M72/M78 "HOP" AUDIO

M72 EVT

CHANGE LIST (CHANGES FROM M51)

APPLE COMPUTER INC.	SIZE	DRAWING NUMBER	REV.
	D	051-7246	0.0.1
SCALE	SHT	OF	
NONE	1	109

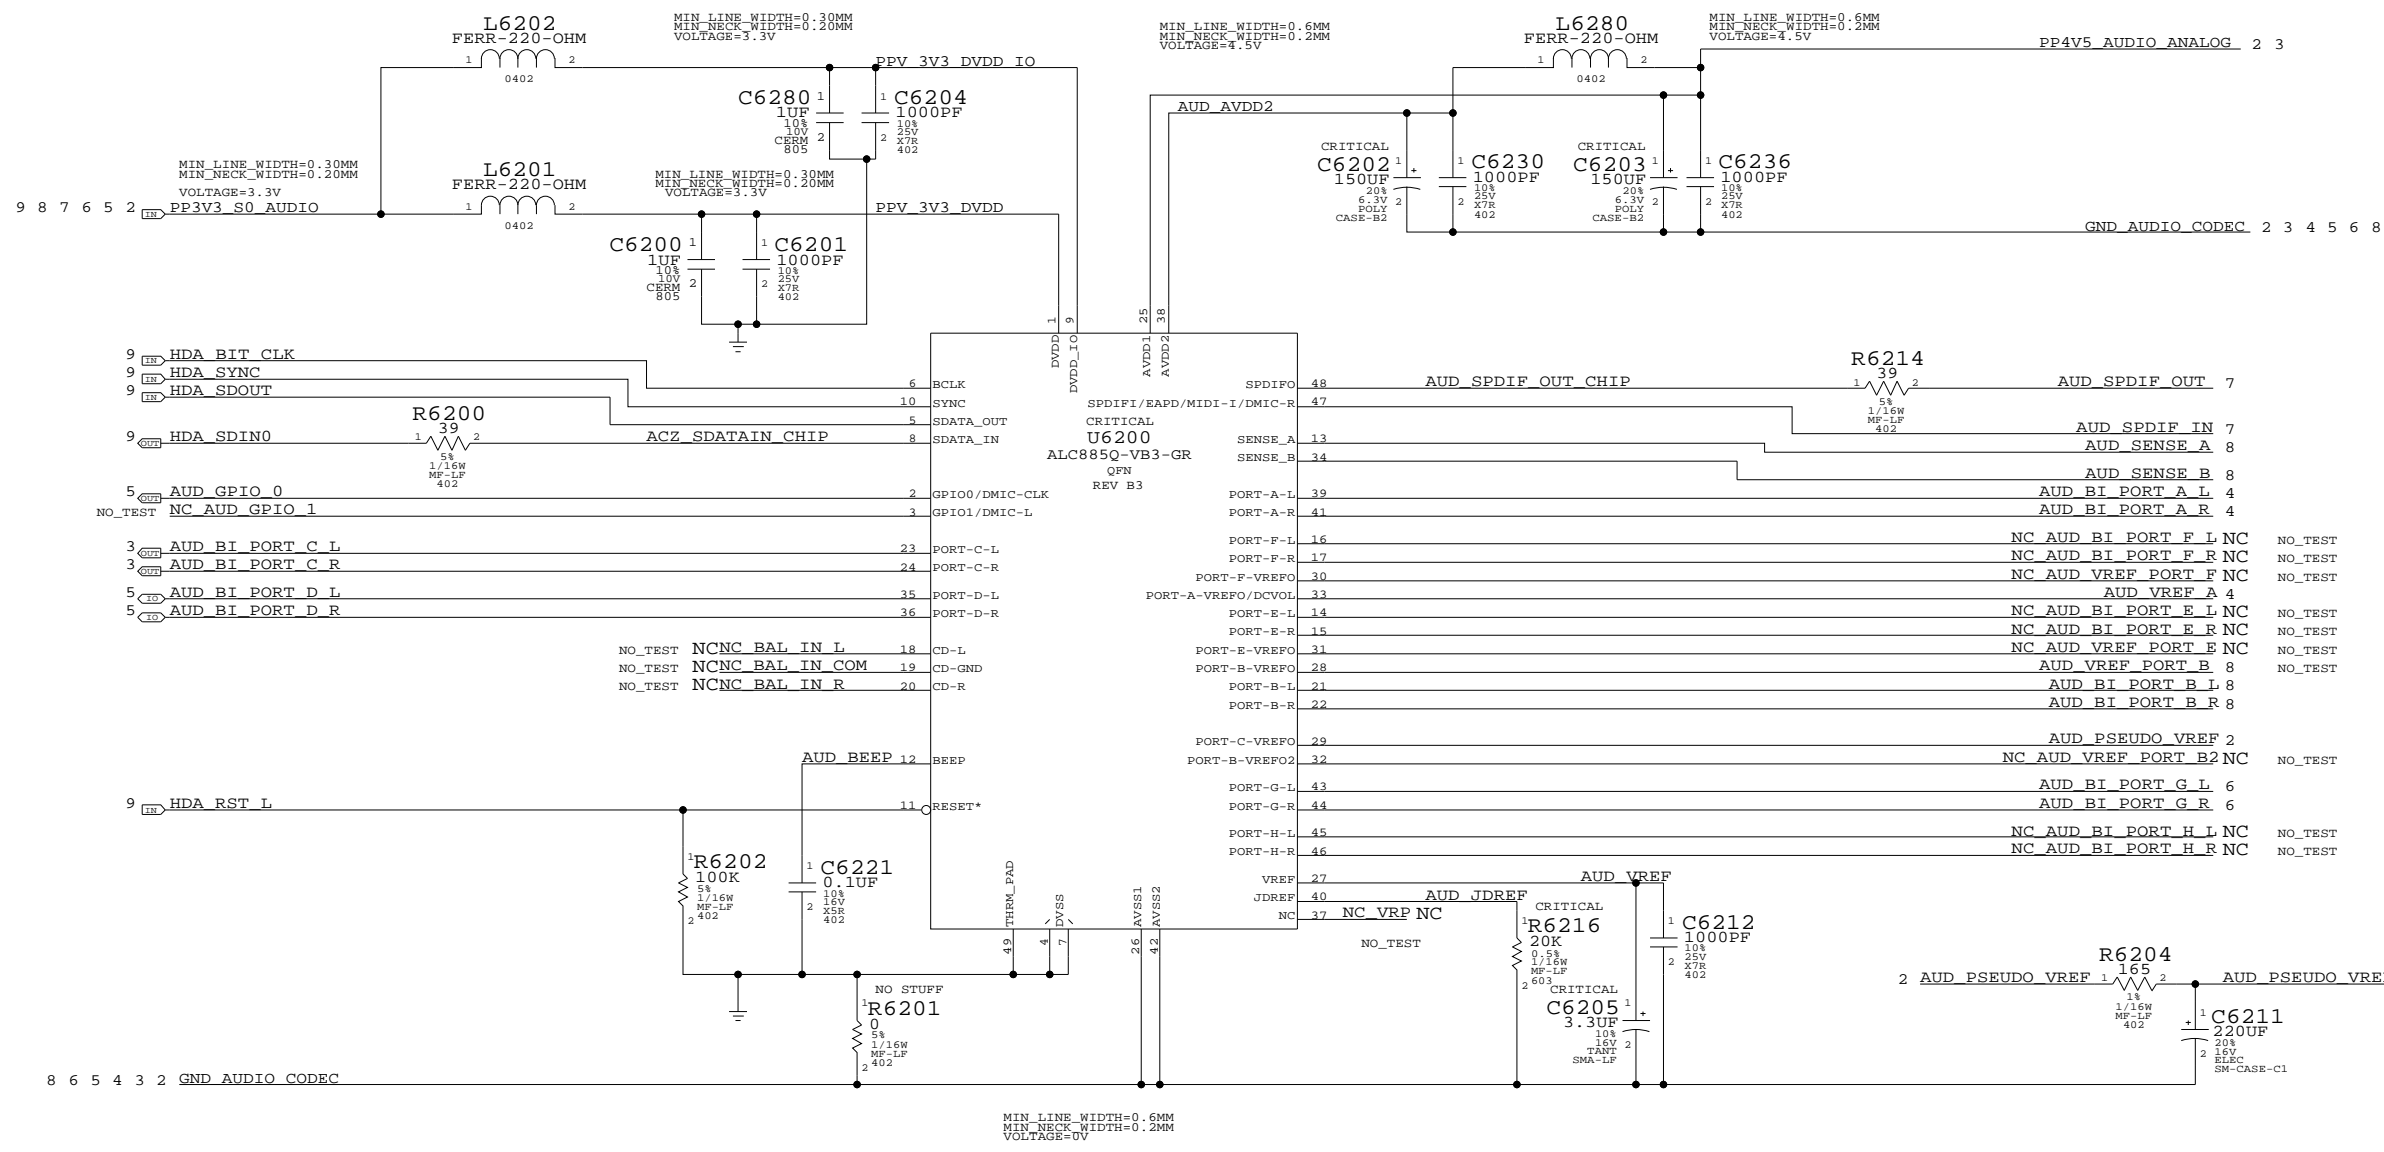
- 29NOV06 AUDIOHW/SW/EFT DESIGN REVIEW HELD (1PM SONNY ROLLINS)
 20. CHANGED L6201/L6202 TO CHEAPER 220 OHM FERRITE BEADS
 21. ADDED NET NAMES TO U6200 PINS 1, U6201 PINS 1, 5, 8, ADDED AUD_ TO BEEP, JDRF, VREF ON PAGE 62

67. CHANGED L6280 TO 220 OHM FERRITE (SAME AS M70/75/76) AND CHANGED C6202/C6203 TO 150 UF FROM 33UF TO IMPROVE THD+N ON HEADPHONES OUTPUT.
- 13 FEB 07

68. ADDED DUAL ANALOG MIC SUPPORT
- 13 MAR 07
 69. CHANGED VREF CAP ON CODEC (C6205) TO 3.3UF FROM 10UF TO ENSURE THAT THE VREF IS FULLY CHARGED WHEN SPKR AND HP AMPS ARE UNMUTED

AUDIO: LINE INPUT AMP

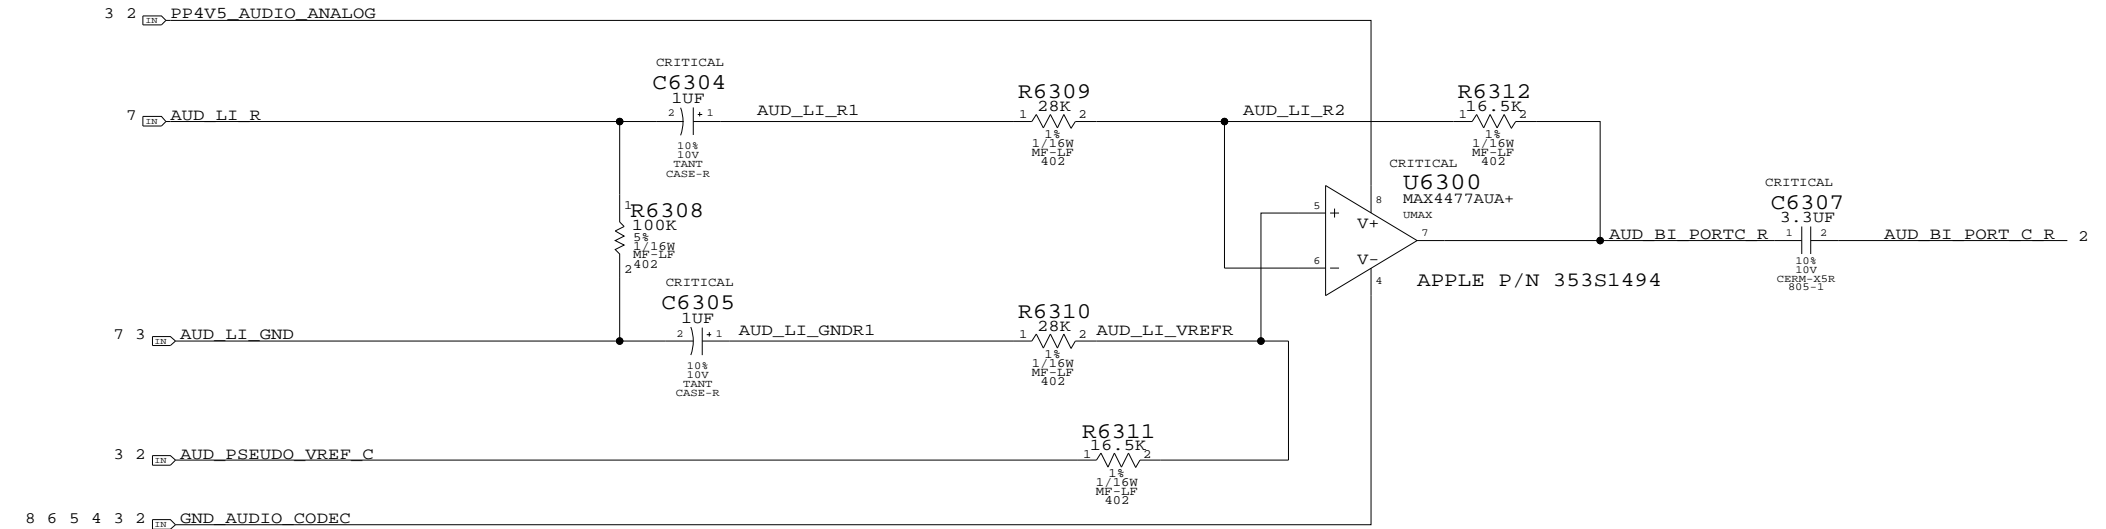
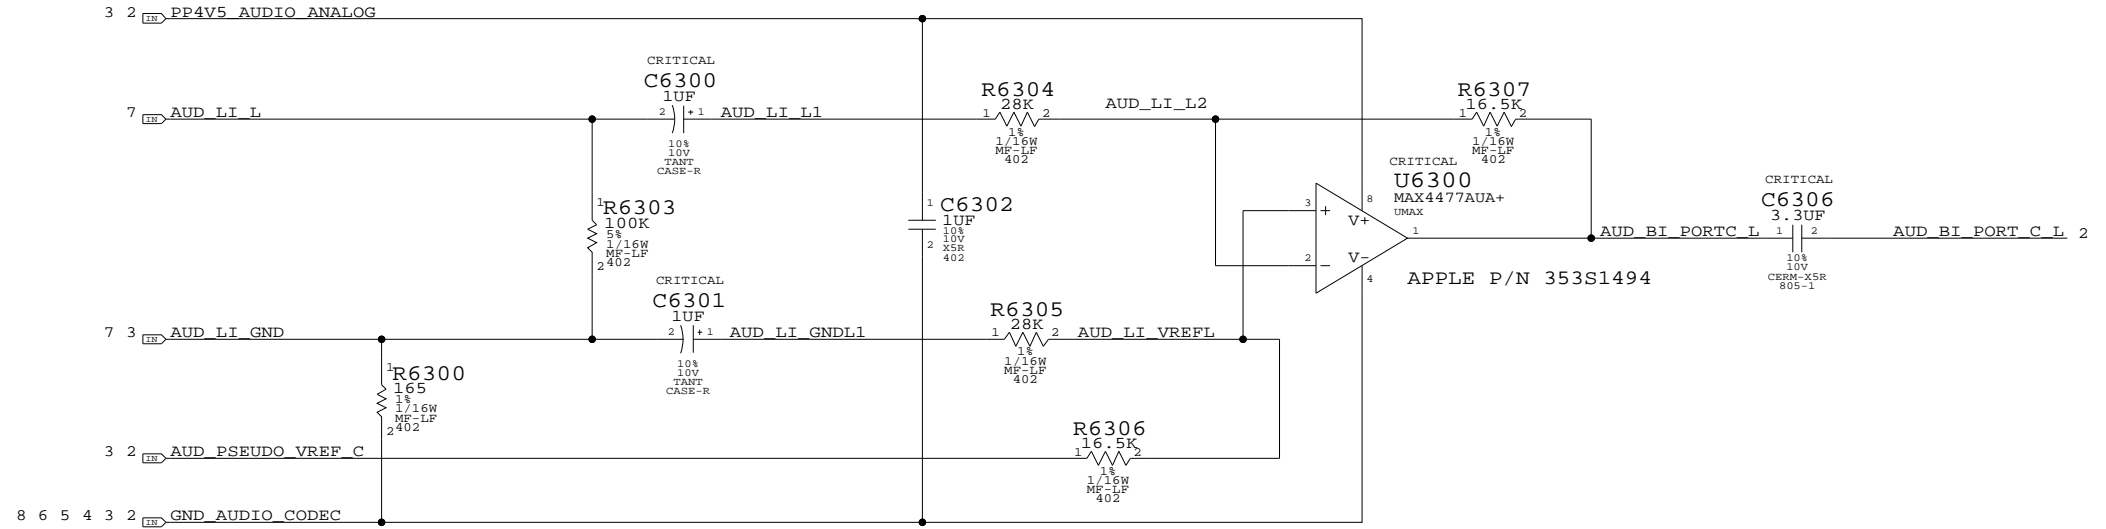
22. CHANGED R6308 TO 28K ON PAGE 63
 23. CHANGED R6410 TO 10 OHMS. CHANGED NOTES FROM LINE OUTPUT TO HEADPHONES ON PAGE 64
 24. CHANGED L6506, L6507, L6508, L6605, L6606, L6607, L6608 TO 0402 PACKAGES PAGES 65 AND 66

AUDIO: HEADPHONES AMP

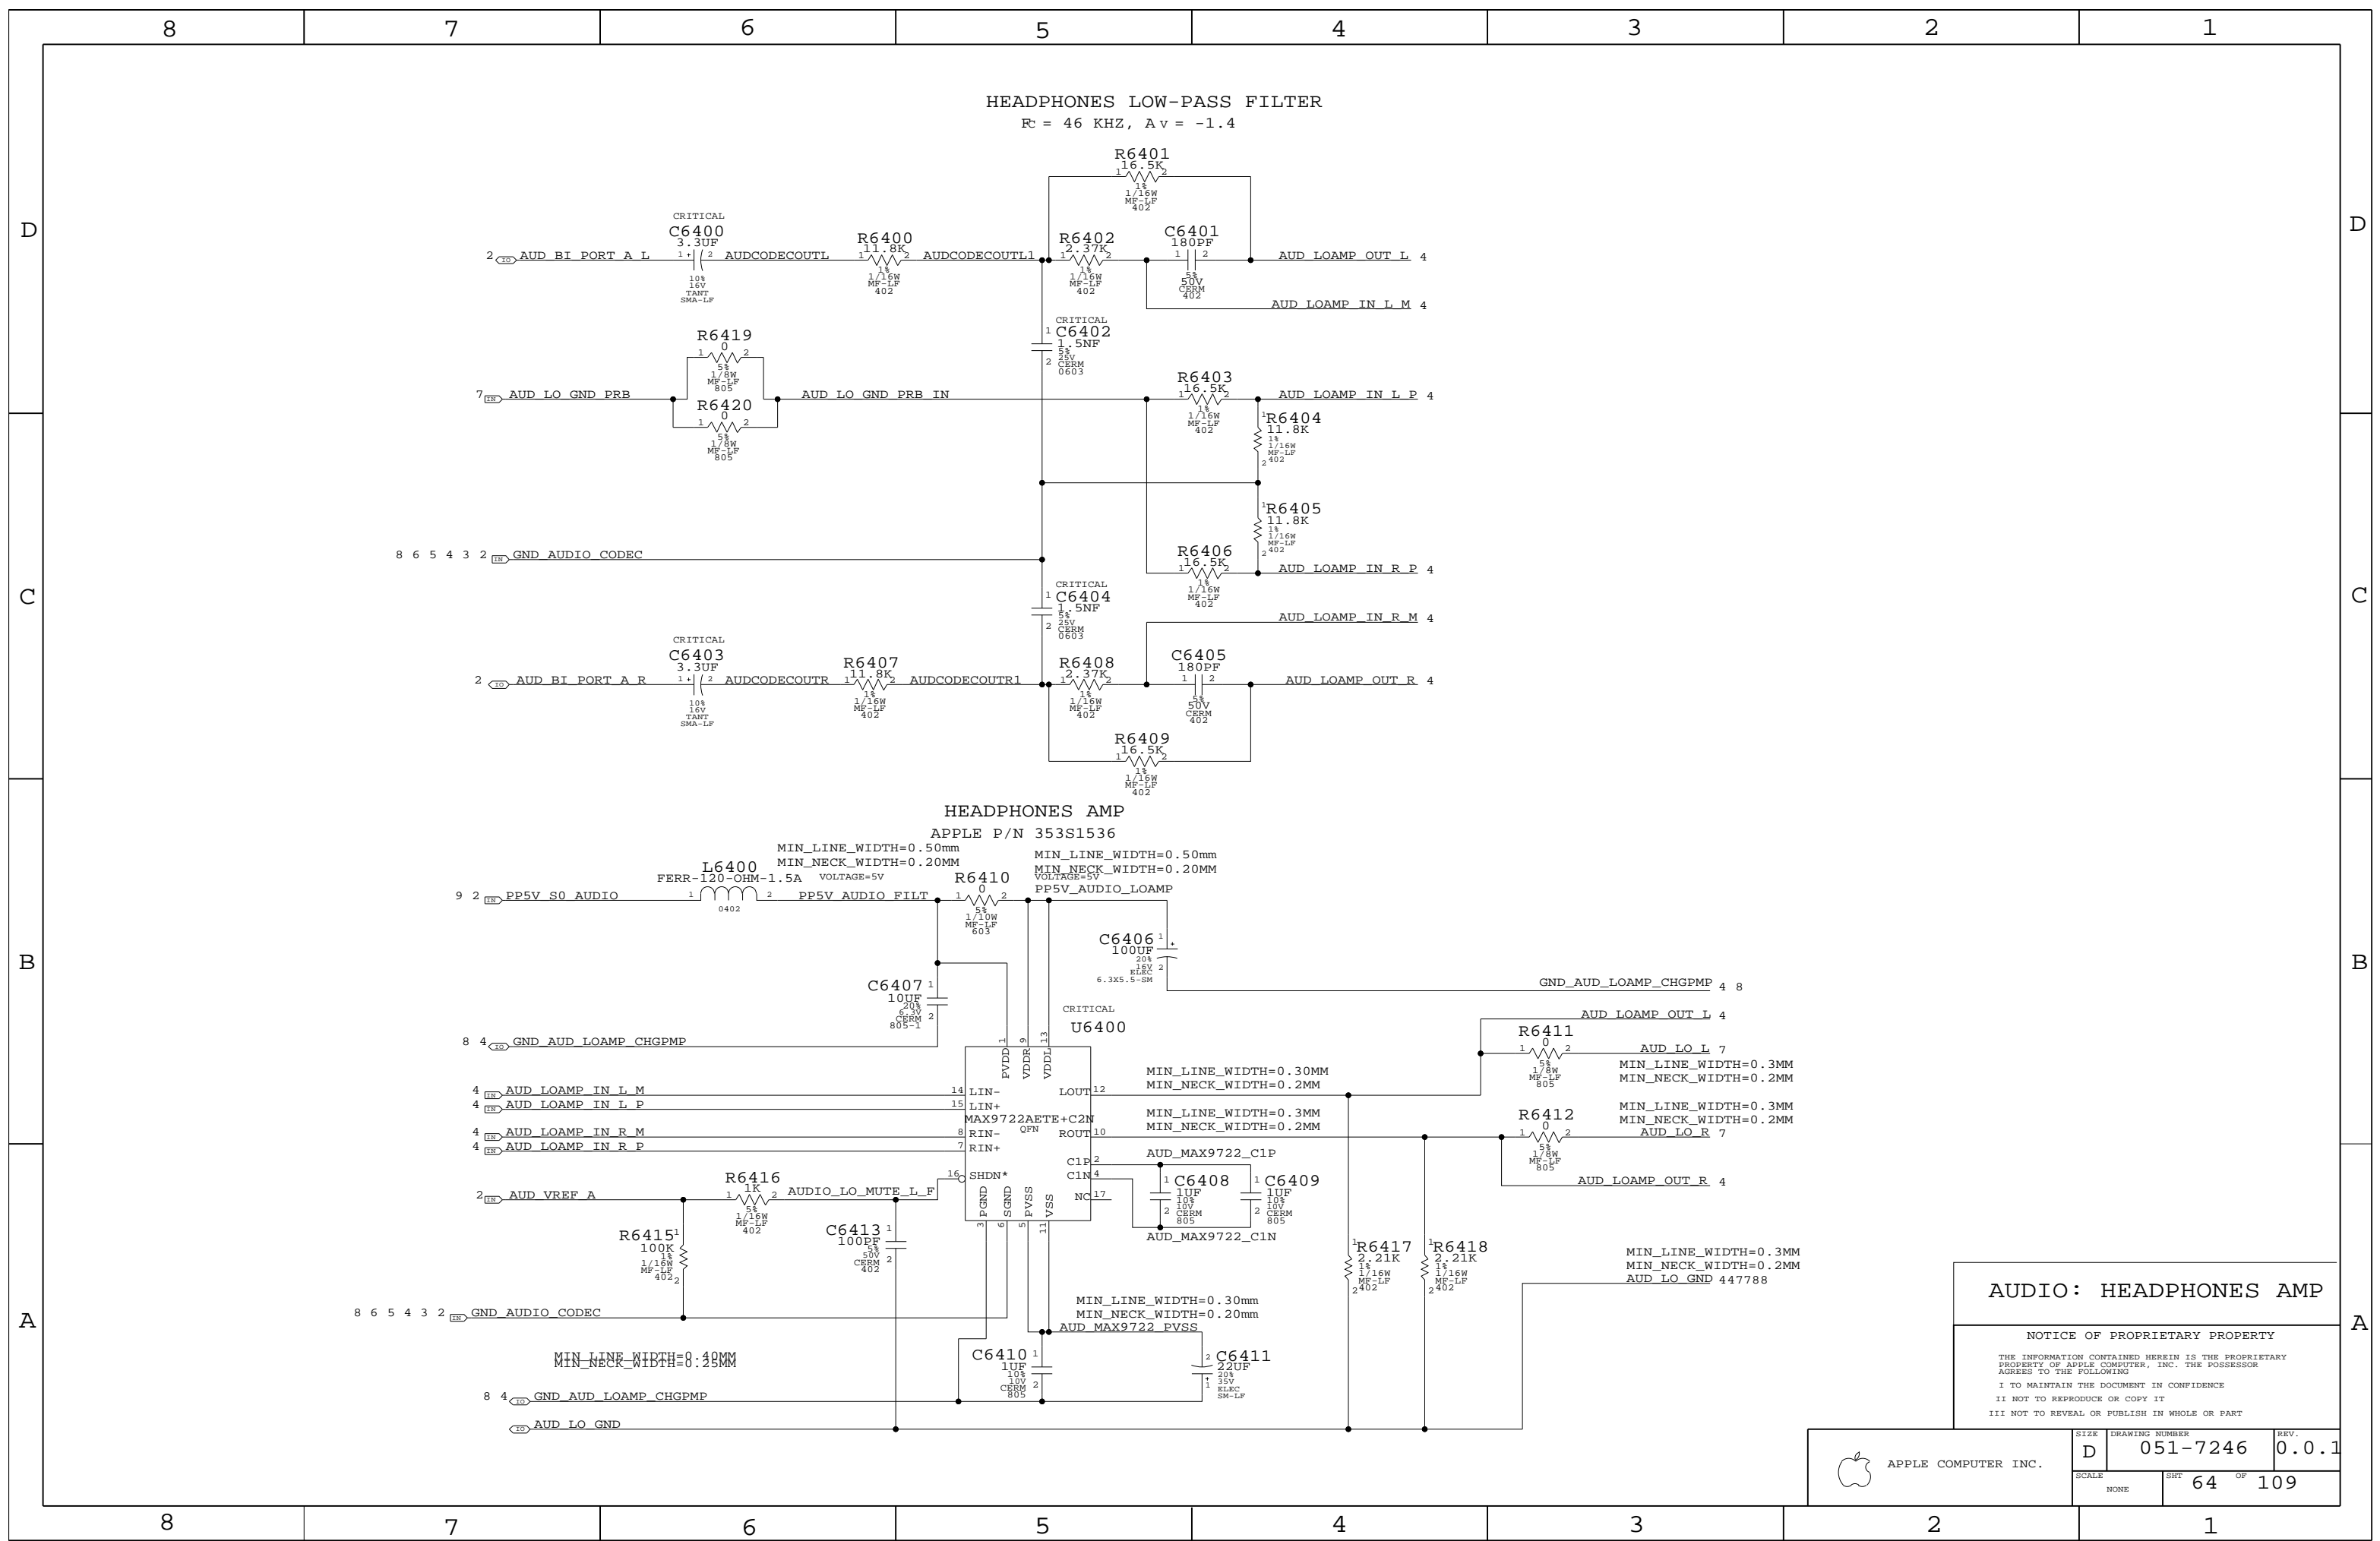
70. CHANGED HP COUPLING CAPS (C6400, C6401) TO 3.3UF FROM 10UF TO REDUCE POP
 71. ADDED NO-STUFFED R6854 TO CONNECT L AND R CHANNELS TOGETHER FOR MONO MIC IMPLEMENTATION
